ADDENDUM #1

- A. Project Number: 2023-10835
- B. Project Title: Fleck Fuel Facility Replacement
- C. Project Location: STA Valley (Fleck) Service Center, 123 S Bowdish, Spokane Valley, WA 99206
- D. Agency: Spokane Transit Authority

1.4 REVISIONS/CLARIFICATIONS TO PLANS AND SPECIFICATIONS SECTIONS

C1 ELECTRICAL EQUIPMENT RACK ELEVATION & MOUNTING DETAIL (FRONT)
SCALE: NONE

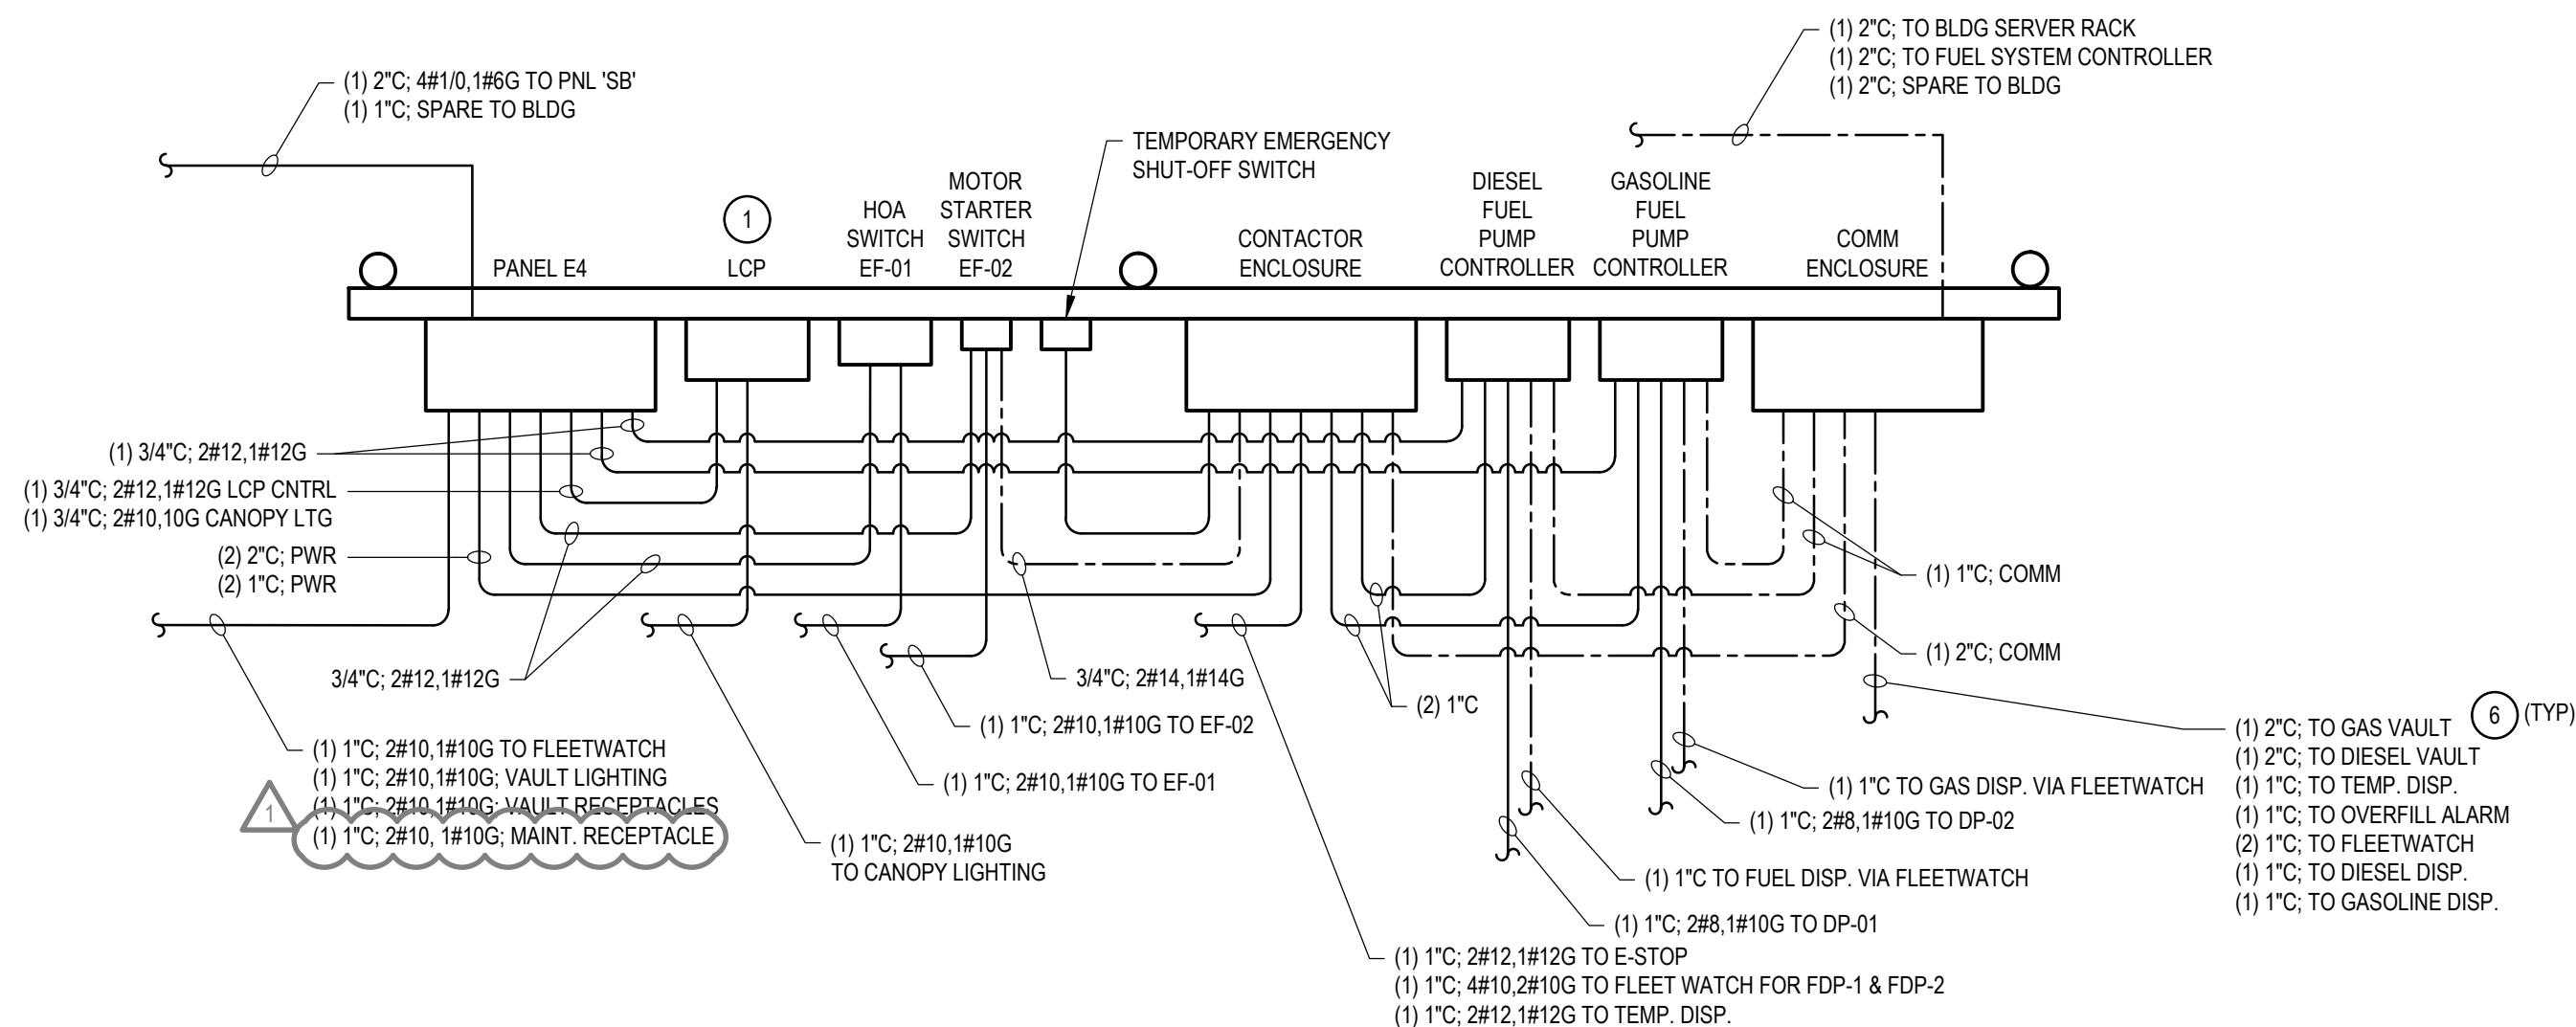
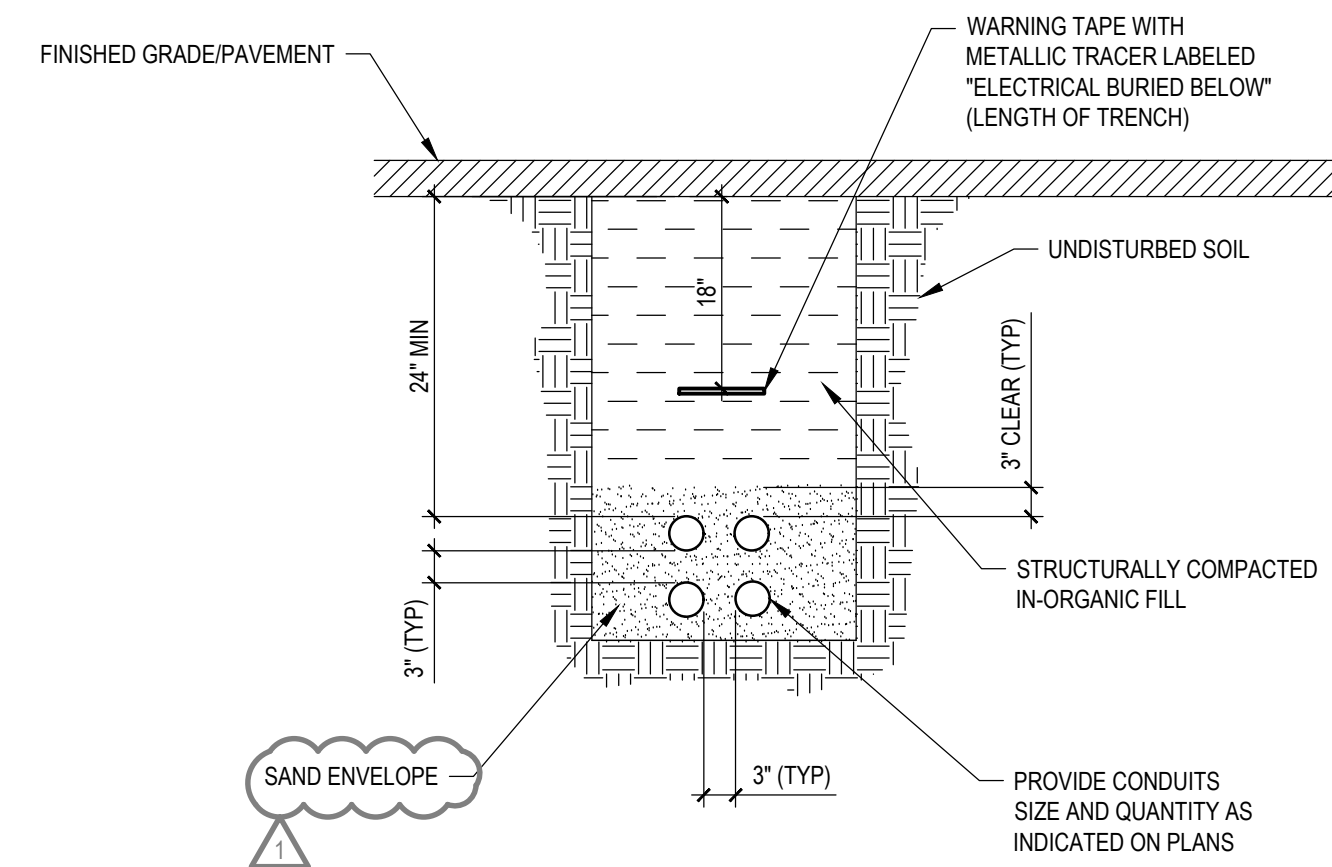
Sheet E-501 –
Added code required convenience receptacle near exhaust fans.
Removed concrete encasement from duct bank detail.
General note and drawing changes for clarification.

Question 10: *Is the electrical crossing in a concrete duct bank?*

Answer 10: This is not required and has been removed. Please refer to the revision to detail A4 on sheet E-501 attached to this addendum.

PANEL AND EQUIPMENT SCHEDULES

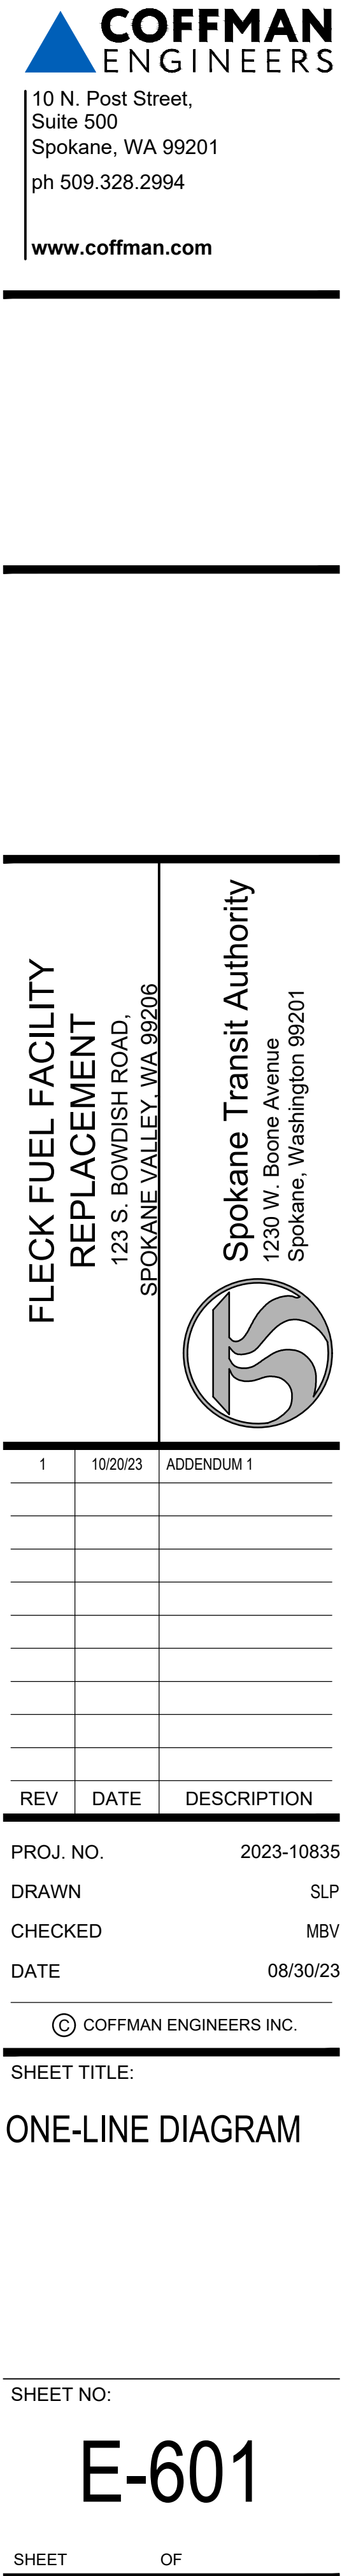
Sheet E-701 –
Added code required convenience receptacle near exhaust fans.
Added E2 Sub-Panel description for clarification.
